Addendum #01 for RFQ #0919335008

Project Name: State Hygienic Laboratory-Ankeny Fume Hood Install and Replacement

Date: 08/24/2018

SHEET NUMBER
G001

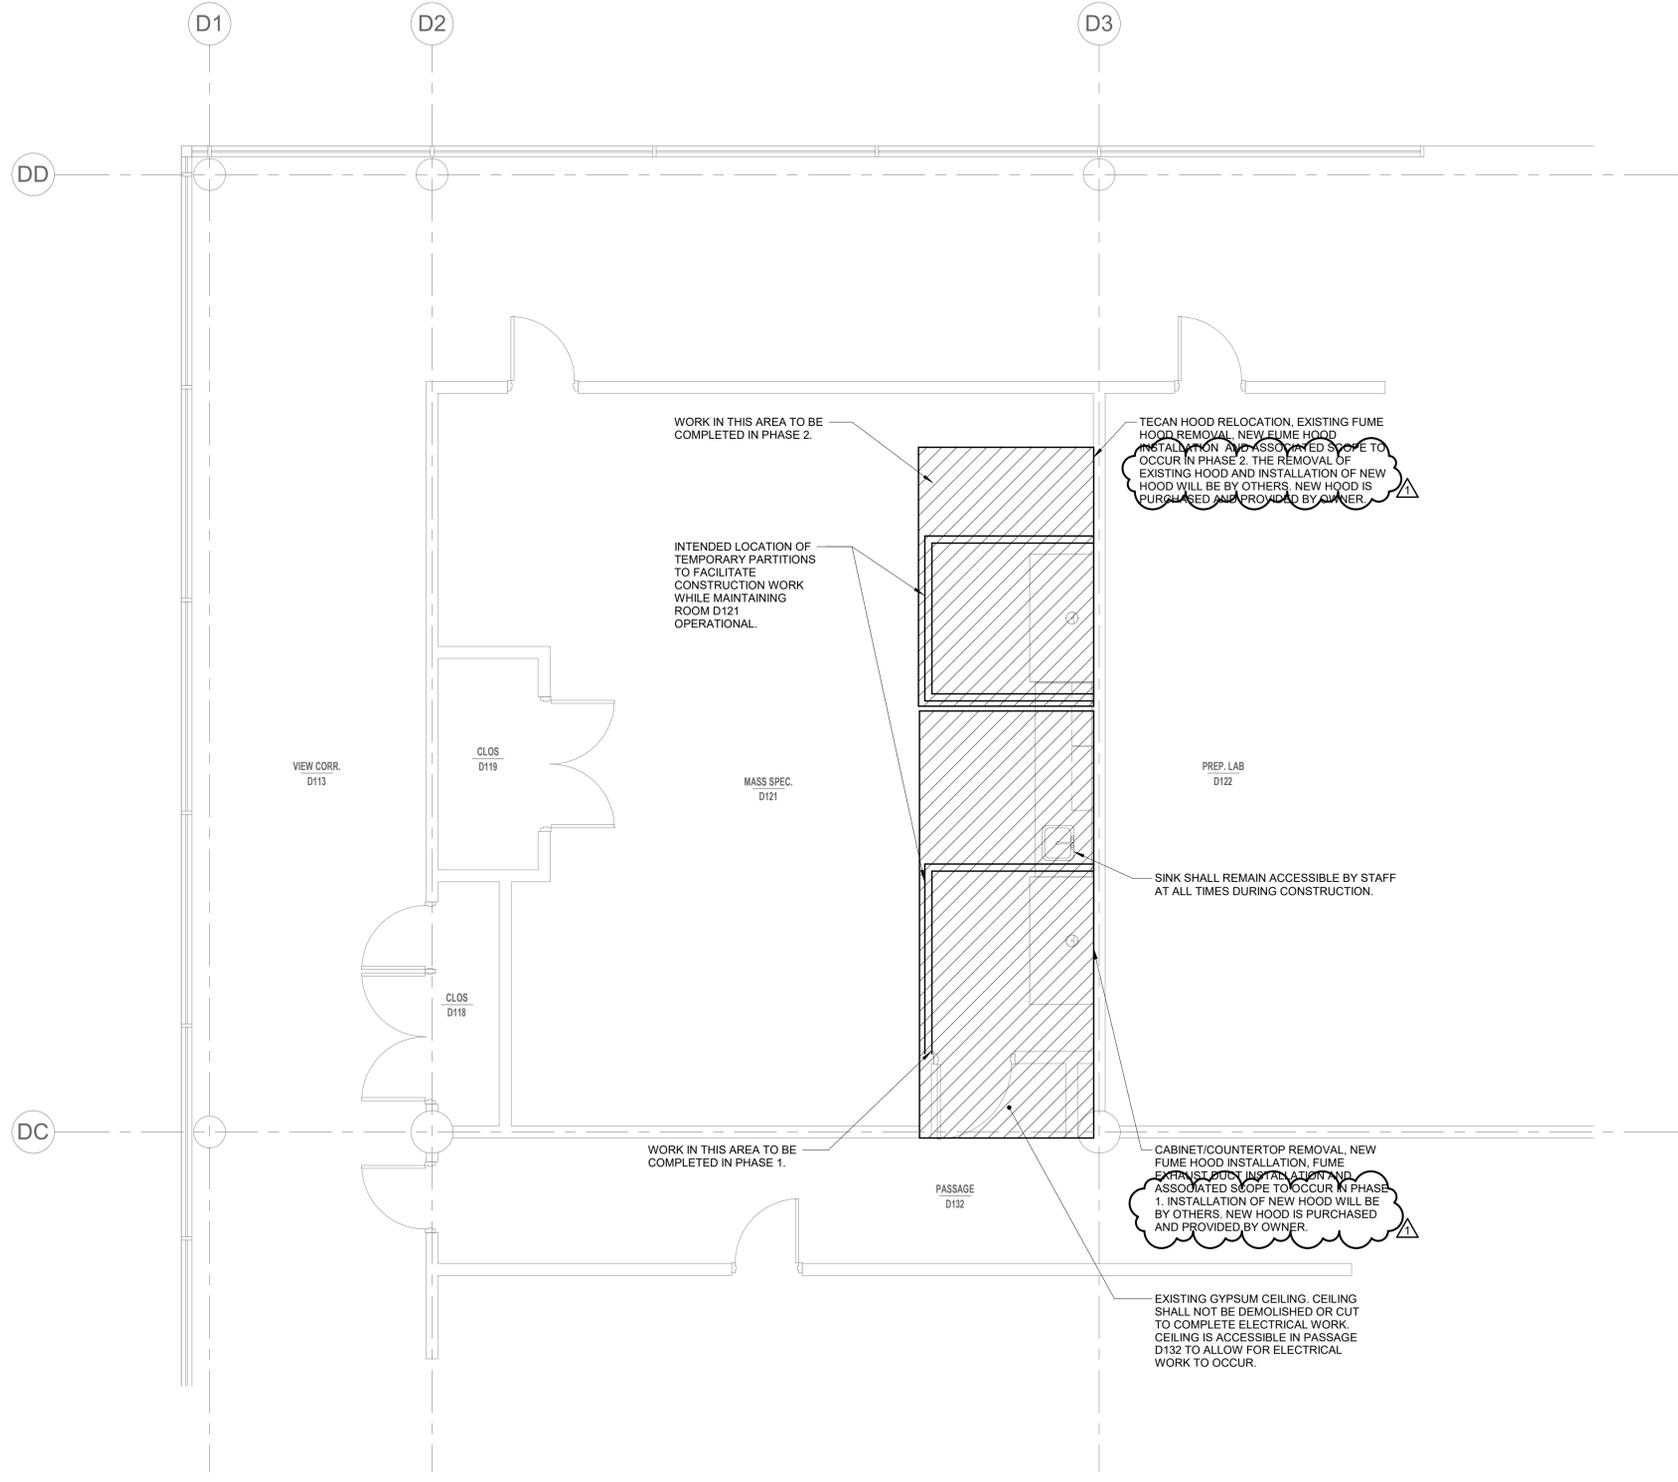
1. G001 – Project Phasing Plan
 - a. **REVISE** notes addressing the installation of the fume hoods. Refer to attached drawing G001 for more information.
2. A1.11 – Proposed and Demo Drawings
 - a. **REVISE** the notes and details in its entirety. Refer to attached drawing A1.11 for more information.
3. M101 – Level 01 - Ventilation
 - a. **REVISE** keynotes 5 and 6. Refer to attached drawing M101 for more information.
4. P101 – Level 01 - Plumbing

P200

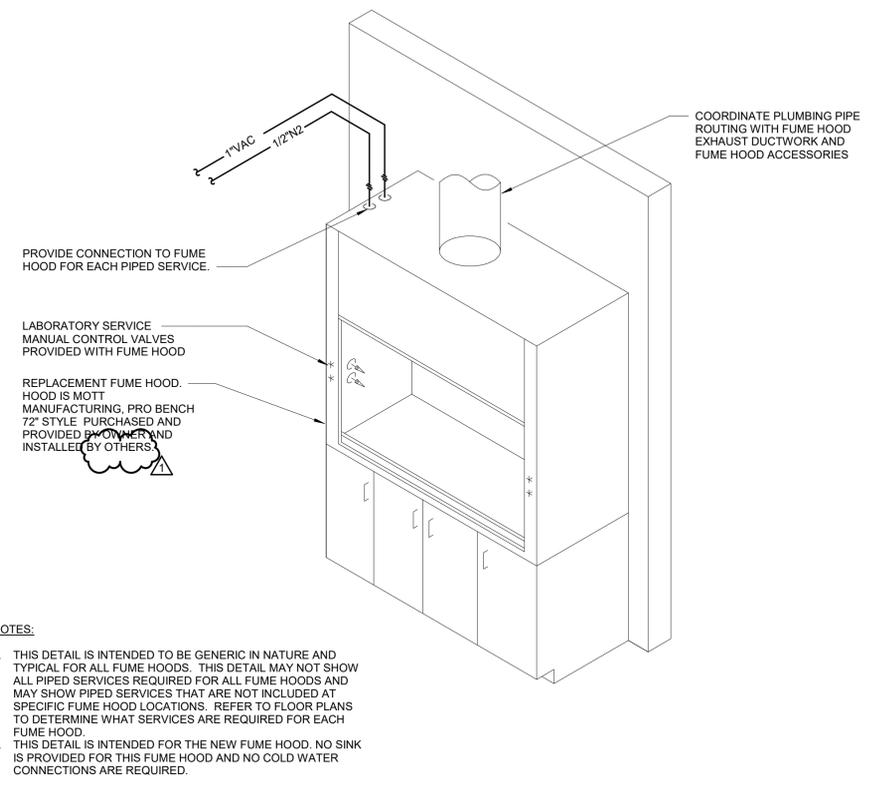
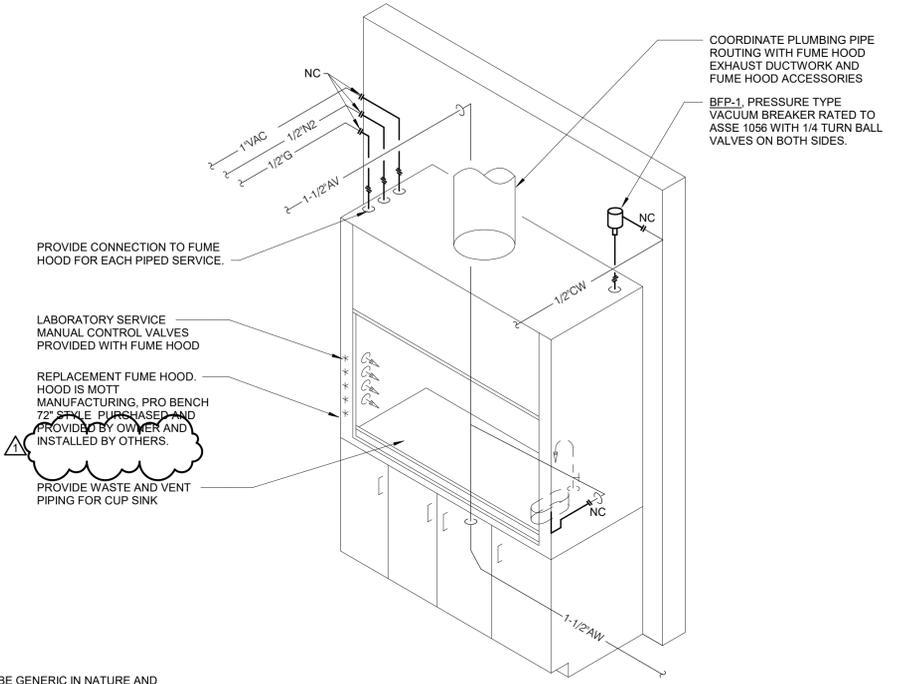
- 5. P200 – Plumbing Details
 - a. **REVISE** details 1 and 2. Refer to attached drawing P200 for more information.
- 6. E100 – Level 01 – Electrical Demolition

- NOTES:**
1. THIS DETAIL IS INTENDED TO BE GENERIC IN NATURE AND TYPICAL FOR ALL FUME HOODS. THIS DETAIL MAY NOT SHOW ALL PIPED SERVICES REQUIRED FOR ALL FUME HOODS AND MAY SHOW PIPED SERVICES THAT ARE NOT INCLUDED AT SPECIFIC FUME HOOD LOCATIONS. REFER TO FLOOR PLANS TO DETERMINE WHAT SERVICES ARE REQUIRED FOR EACH FUME HOOD.
 2. THIS DETAIL IS INTENDED FOR THE NEW FUME HOOD. NO SINK IS PROVIDED FOR THIS FUME HOOD AND NO COLD WATER CONNECTIONS ARE REQUIRED.

- NOTES:**
1. THIS DETAIL IS INTENDED TO BE GENERIC IN NATURE AND TYPICAL FOR ALL FUME HOODS. THIS DETAIL MAY NOT SHOW ALL PIPED SERVICES REQUIRED FOR ALL FUME HOODS AND MAY SHOW PIPED SERVICES THAT ARE NOT INCLUDED AT SPECIFIC FUME HOOD LOCATIONS. REFER TO FLOOR PLANS TO DETERMINE WHAT SERVICES ARE REQUIRED FOR EACH FUME HOOD.
 2. THIS DETAIL IS INTENDED FOR THE REPLACEMENT FUME HOOD. A CUP SINK IS PROVIDED WITH THIS FUME HOOD AND REQUIRES A COLD WATER CONNECTION.

E100

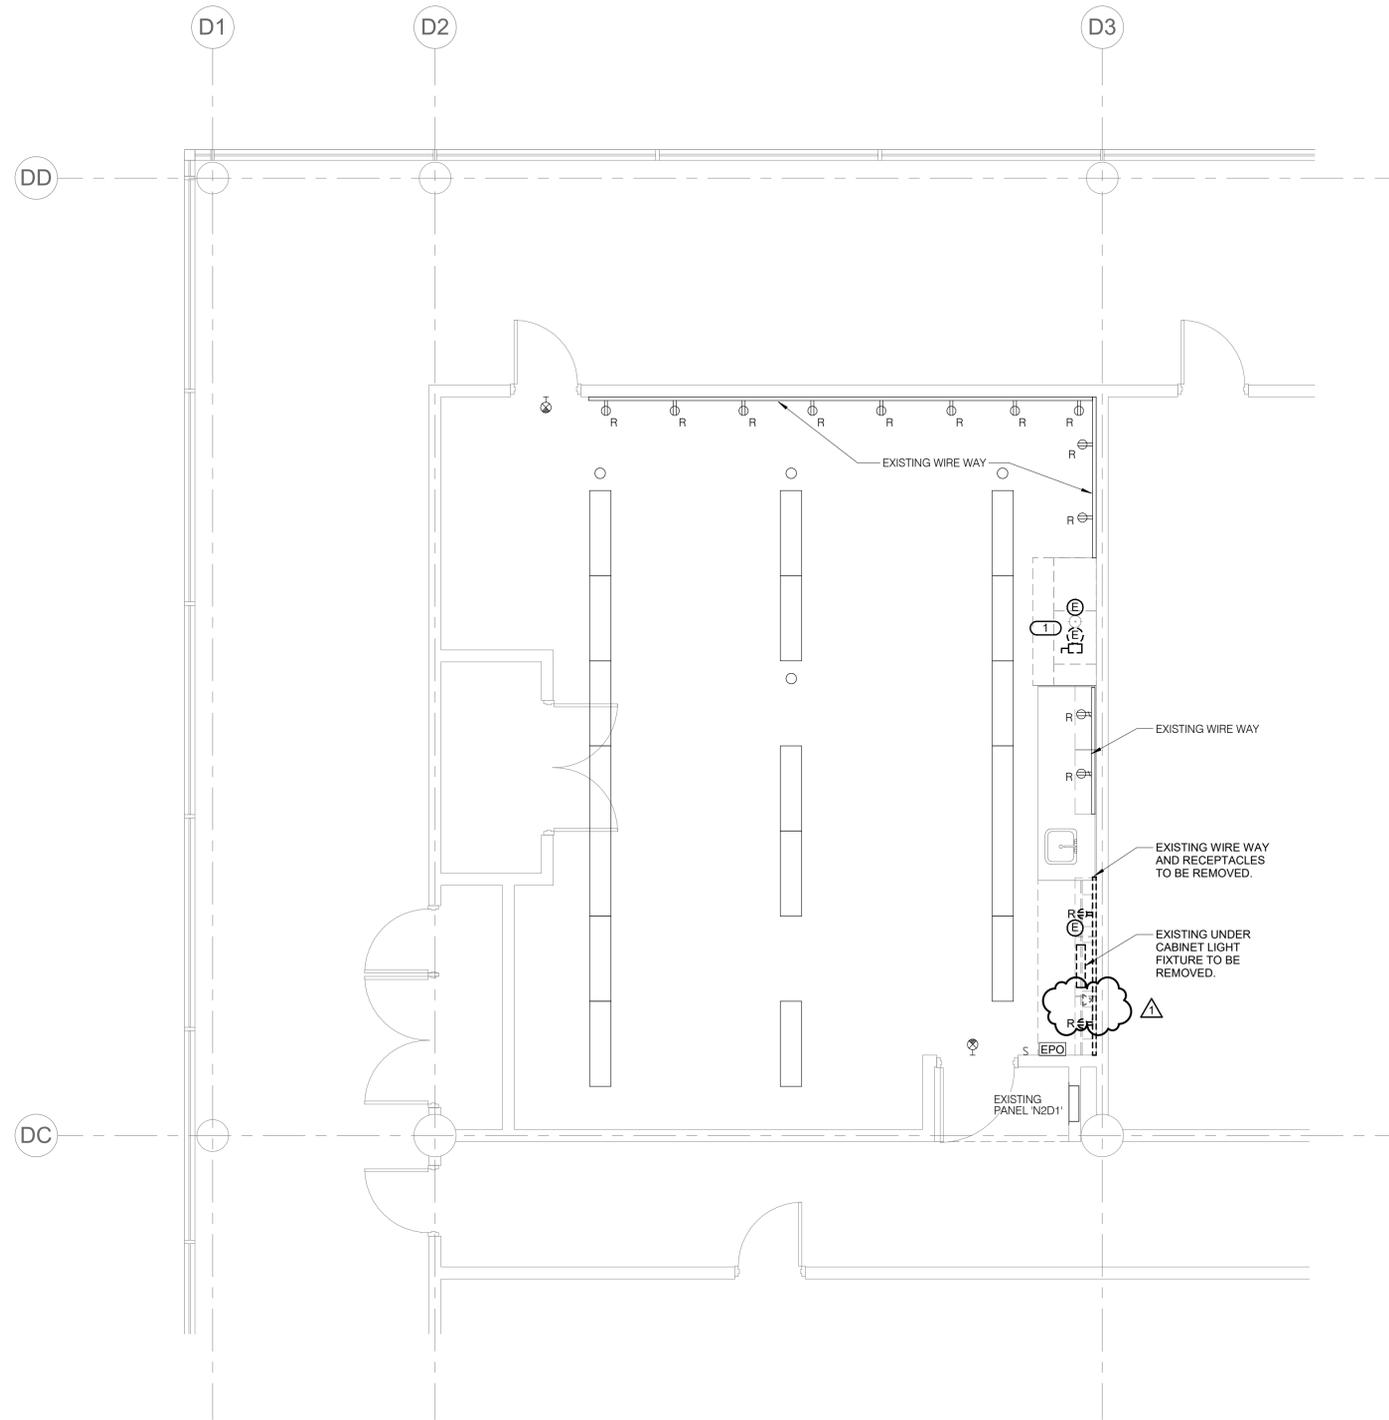
- a. **REVISE** keynote #1 to read “DISCONNECT POWER TO HOOD FOR REMOVAL BY OTHERS. CONDUIT AND WIRE SHALL REMAIN FOR REUSE. REFER TO E101 FOR MORE INFORMATION”. Refer to attached drawing E100 for more information.

- b. **ADD** demolition of one (1) telecommunication box in wireway above counter being removed. All cabling shall be removed back to source. Refer to attached drawing E100 for more information.

KEYNOTES:
1. DISCONNECT POWER TO HOOD FOR REMOVAL BY OTHERS. CONDUIT AND WIRE SHALL REMAIN FOR REUSE. REFER TO E101 FOR MORE INFORMATION.

2 FUME HOOD DETAIL
NO SCALE

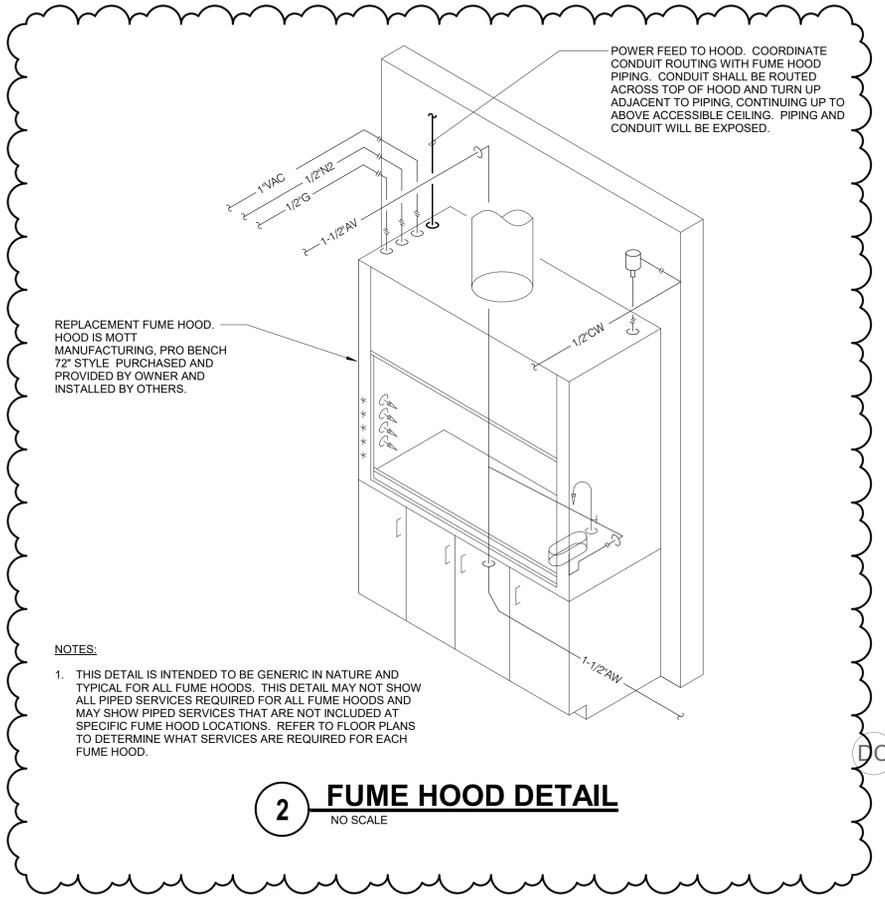
- 7. E101 – Level 01 – Electrical
 - a. **ADD** detail 2 to clarify hood feeder/conduit installation. Refer to attached drawing E101 for more information.

- KEYNOTES: (#)**
- CONNECT NEW HOOD TO EXISTING HOOD CIRCUIT. EXTEND CONDUIT AND WIRE AS NECESSARY.
 - CONNECT NEW HOOD TO EXISTING 20A/1P SPARE CIRCUIT IN EXISTING PANEL 'N2D1' USING 2#12 & 1#12 GND IN 3/4" CONDUIT.
 - COORDINATE EXISTING CONDUIT AND JUNCTION BOXES WITH NEW DUCT WORK FOR FUME HOOD. REROUTE CONDUIT AND JUNCTION BOXES AS NECESSARY. COORDINATE WITH M.C. AND CONSTRUCTION DOCUMENTS PRIOR TO REROUTING.
 - LIGHT, LIGHT SWITCH, AND DUPLEX RECEPTACLES ARE INSTALLED AND PRE-WIRED IN HOOD BY MANUFACTURER.
